Historic District Review Committee

Staff Report

CAPP2011-0012

CAPP 2011-0012 Brian & Polly Ahalt: New Residential Construction. PIN #491-19-4157.

Figure 2: General Area of proposed house, note steep slopes in yellow and surrounding topography

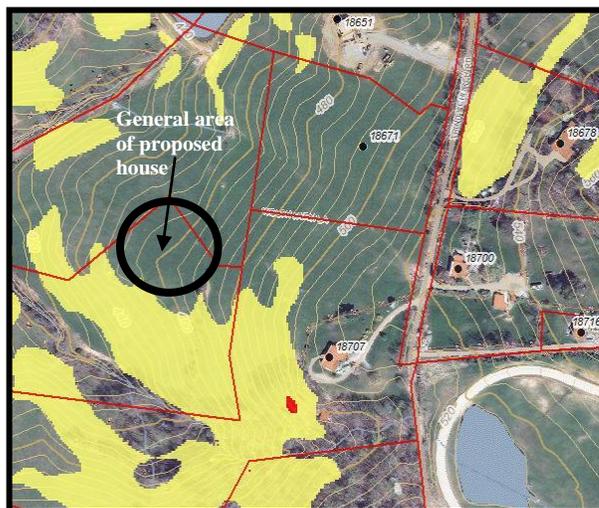
The Guidelines state that new construction should be sited according to historic precedents (Goose Creek Guidelines, Guidelines for Site Elements, Siting, page 39, Guideline 1). Farm houses were typically sited between two higher landforms, on a saddle of land, rather than the on the ridge of a hill. The proposed house is sited on a flatter area of the property in order avoid extensive grading within the large areas of moderately steep slopes (see yellow shaded areas in Figure 2). While the proposed house site is at a high spot on the subject property, the proposed site is not the highest point in the surrounding area and the site is well shielded by the sloping topography on adjacent sites. The surrounding historic houses are sited closer to Trinity Church Road than the proposed house. However, the property does not have road frontage on any public road and is therefore unable to mimic the historic precedents for setbacks. **The proposed site meets the Guidelines for siting of new construction.**

Figure 3: Currently Proposed Siding with faux wood grain

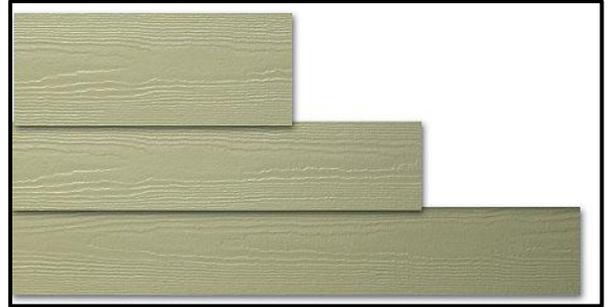
- and workability of wood (Goose Creek Guidelines, Guidelines for New Construction, Materials and Textures, page 80, Guideline 9). The elevations specify “cedar mill” which has a faux wood-grain rather than a smooth finish. The Guidelines support smooth-finish cementitious products (Goose Creek Guidelines, Guidelines for New Construction, Materials and Textures, page 80, Guideline 7). The six inch reveal is consistent with the Guidelines. **Staff recommends a condition of approval to use smooth finish Hardieplank in lieu of the cedar mill as currently proposed.**

1. That the house is rotated slightly towards Trinity Church Road to lessen the view of the side entry garage from the end of the road.
2. That the white trim band on the left and right side elevations is eliminated and replaced with siding at a six-inch reveal.
3. That the door is smooth finish fiberglass.
4. That the windows are six-over-six or one-over-one.
5. That the Hardieplank siding is smooth finish.
6. That the porch floor is wood (other than exposed pressure treated lumber).
7. That the foundation is veneered in a locally available stone.
